Access Compliance Report

Public Rights-of-Way

| Intersection ID: 44955 | Main Street: OAKTON_HUNT_DR | Cross Street: WEAVERS_GLENN_PL | Location: NE |
| ADA ID: 4A9D0422A0E5 | Ramp Type: Perp | Initial Pass/Fail: Fail | Overall Compliance: No |

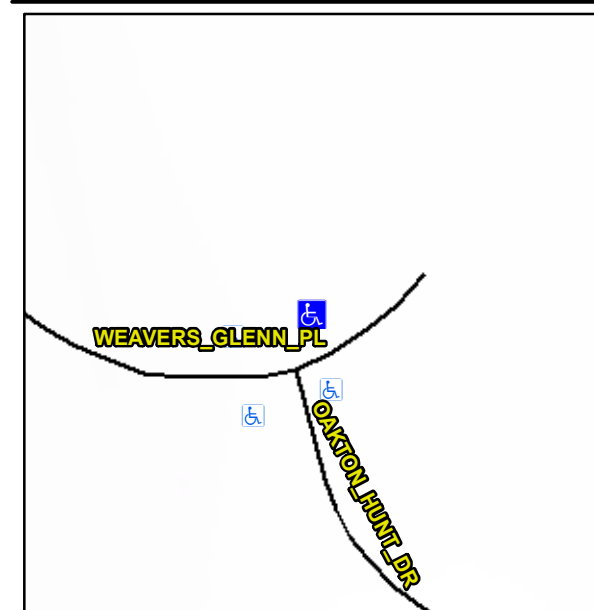
Not Found, R304.5.3

| Compliance | Description | Data | Compliance | Description | Data |
|------------|-----------------------|------|------------|-----------------------------|------|
| Yes | Ramp Width (in) | 49.0 | No | Ramp XSlope (%) | 5.1 |

Remove & Replace Entire Ramp.
